C-BLOCK POCKET PLAZAS

B-BLOCK POCKET PLAZAS

B-BLOCK - THE PLAZA OPEN SPACE

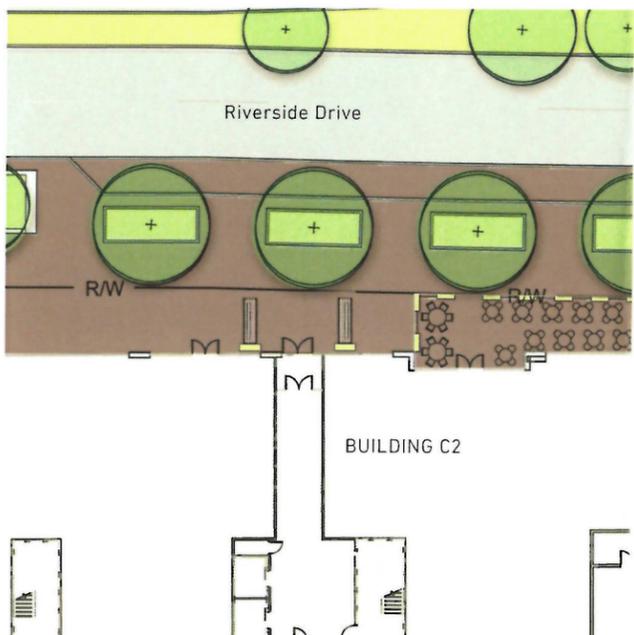
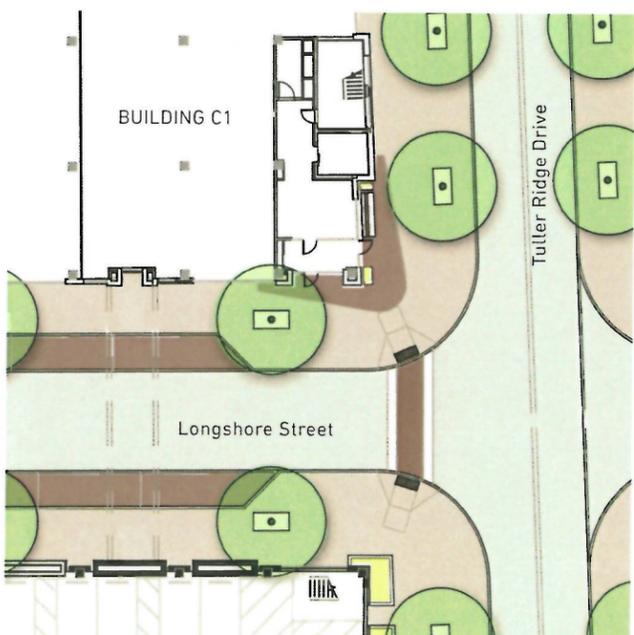
- A Civic Gateway**
These areas should remain as designed to mark the permanent entrance to the development along the signature street.
- B Permanent Building Entries**
These areas should be simplified to incorporate the adjacent sidewalk paving material and site furnishings.
- C Tenant-Driven Space**
These areas should be returned to brick sidewalk to allow for maximum flexibility and a variety of visual interests through tenant improvements.
- D Isolated Space**
This area should be simplified due to lack of activation or likelihood that pedestrians will occupy them.

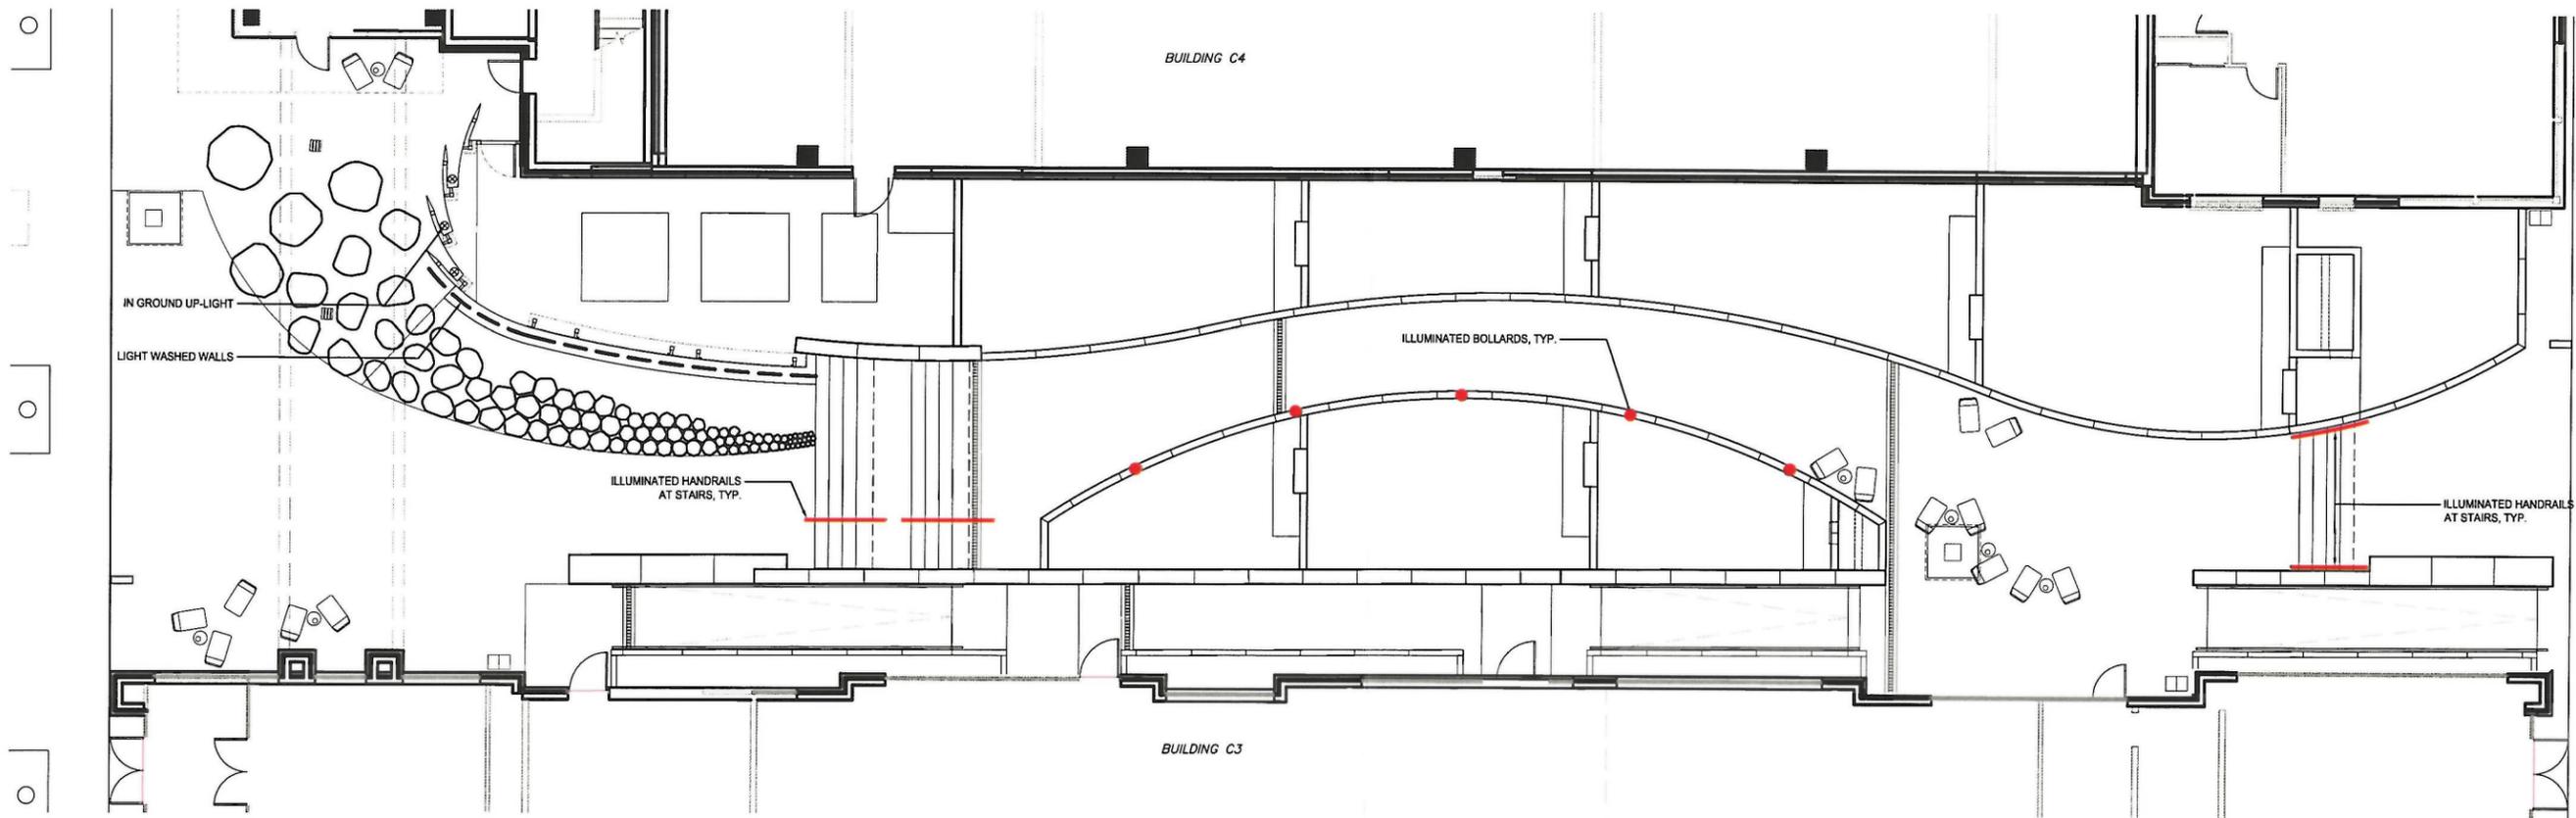
Planter area is relatively insignificant to allocate significant resources and construction complexity for little return. Requesting to change the current bio-retention planter to a typical planter without bio-retention.
